## DRAINAGE LETTER

### **Woodmen Frontage Road Turn Lane**

DATE:  
**January 10, 2022**

### **Drainage Map**

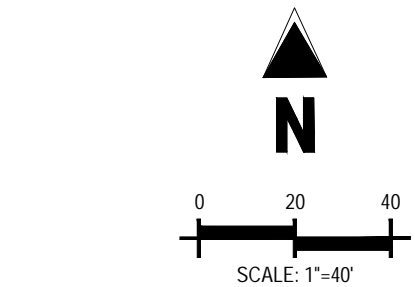
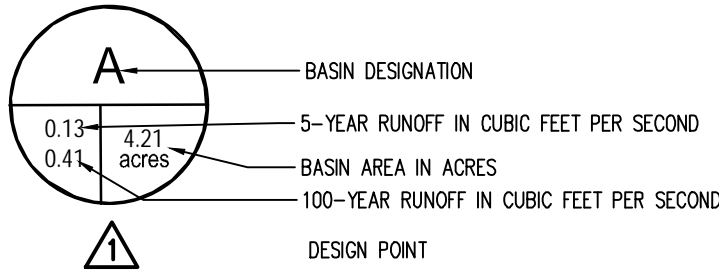
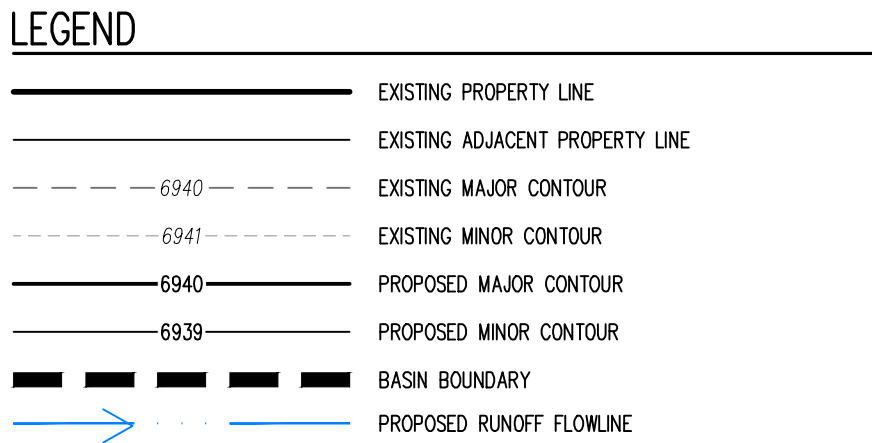
Please include existing drainage map

GALLOWAY - ADDED
